UNITED NUCLEAR
C O R P O R A T I O N

Relative to your letter dated September 18, 1978, requesting additional data and analysis of the effluent embankment foundation, attached hereto are ten (10) copies of the response. This information becomes Addendum III to the Dames and Moore Report of Investigation and Design as amended.

QUESTION NO. 1

RESPONSE TO QUESTION NO. 1

LOG OF BORINGS

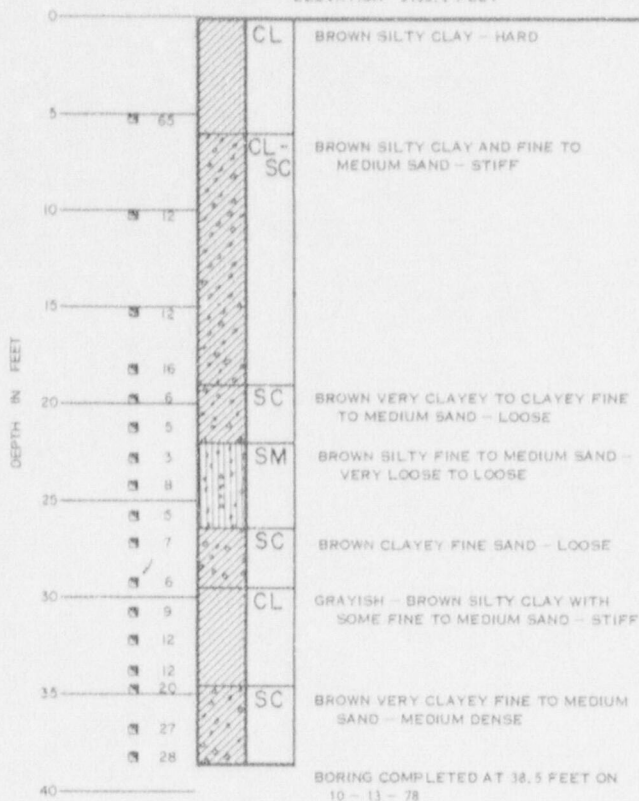
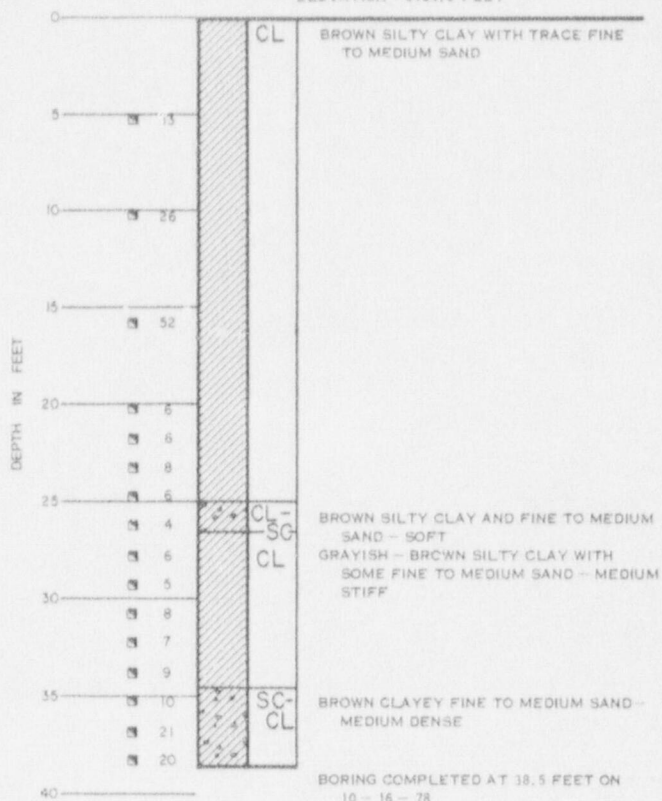
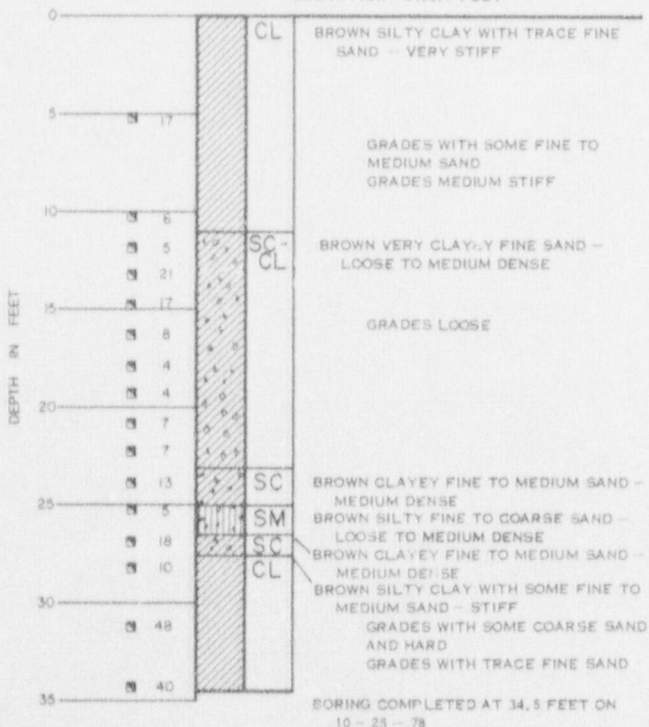
Submit to NRC additional data and analyses to show that the loose sands in the embankment foundation are clearly safe against liquefaction for a 1,000-year return interval earthquake or submit for approval a plan for remedial work to ensure safety against liquefaction. In either case, documents to be submitted to NRC should include additional boring logs with standard penetration tests to show the extent of the loose material in the embankment foundation and Atterberg limit tests for material classification.

Logs of seven additional borings drilled in the valley alluvium are presented on Plates 1A and 1B. The locations of the borings are shown on Plate 2, Plot Plan.

The borings were drilled utilizing hollow-stem auger equipment. Standard penetration tests were conducted at close intervals in the borings. The holes were advanced with the augers, the augers were filled with water, and the SPT sampler was driven 18 inches. The blows per foot of penetration for the last 12 inches are reported on the left side of the boring logs on Plates 1A and 1B.

of loose to medium dense, clayey, fine to medium sand (SC-CL to SC), generally occurs from depths of 20 to 30 feet. The sand is plastic, having a plasticity index ranging from 5 to 20 (Table 1). Two pockets of loose, silty, fine to coarse sand were encountered in Boring 5A at a depth of 22.0 to 26.5 feet and Boring 21 at a depth of 25.0 to 26.5 feet.
